## **Cape Dorset Water Supply Main Rehabilitation Review**

**Summary Report  
Cape Dorset Water Supply Main  
Rehabilitation Review**

Prepared for:  
**Department of Community and Government Services  
Government of Nunavut  
P.O. Box 379  
Pond Inlet, NU X0A 0S0**

Trow Associates Inc.		CAPE DORSET WATER MAIN STABILIZATION	
154 Colonnade Road South, Ottawa, Ontario K2E 7J5		CLIENT	
Tel: (613) 225-9940 Fax: (613) 225-7337		TITLE	
Trow Job No. OTC00017470A		DATE: FEB. '05	DRAWING NO. <b>SK-4</b>
		SCALE: N.T.S.	REV. 0

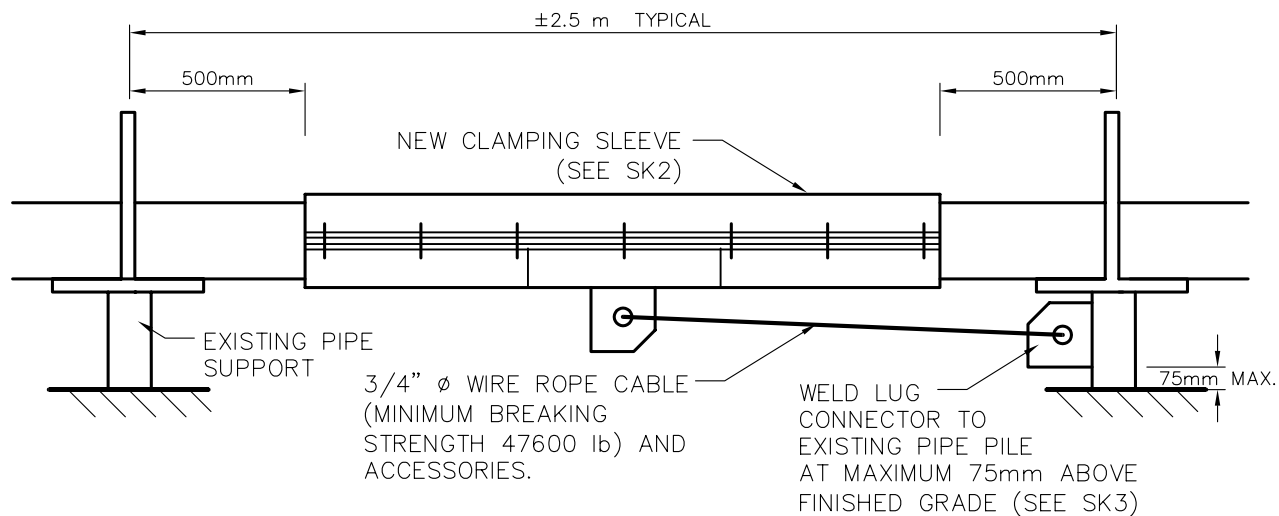
A total of twelve (12) restraints were added to the pipeline. The following is a summary of the locations of the installed sleeves. Refer to SK4 for approximate locations.

1. One clamped sleeve installed below the pump heater house. Four sleeves at 5 metre intervals were requested in this area. Weather conditions did not permit the use of any motor vehicle. The contractor attempted to use one of the existing rock anchors to hold the sleeve. We had specified the use of lugs on the supports. Since the rock anchors failed, he did fix the lug onto the support as specified.
2. A total of eleven restraints were installed between the Truck Fill Station and the Expansion Loop.
  - One (1) restraint was installed immediately below the roadway crossing. None were specified in this area.

- Three (3) restraints were installed immediately above the roadway crossing at intervals of approximately 30 metres along the flatter terrain. These were placed in the vicinity of junction boxes, at approximately 70 metre intervals.
- The remaining seven (7) were installed at approximately 35 metre intervals below the expansion loop. One of the restraints was fixed at the lower leg of the expansion loop. Four sleeves were requested immediately downhill of the expansion loop at 5 metre intervals.

The work performed is not consistent with the Remedial Measure Procedures provided to the Government of Nunavut and the Contractor on September 3<sup>rd</sup>, 2004. The principle concerns arising from the 2004 works are as follows:

2. The Contractor indicated that he did not purchase rock anchors as specified on the September 8<sup>th</sup> Materials list for the 2005 stabilization of the pipeline. The current pipeline support piles in this location will not provide adequate lateral resistance. Furthermore, adfreeze piles in this location are not viable.
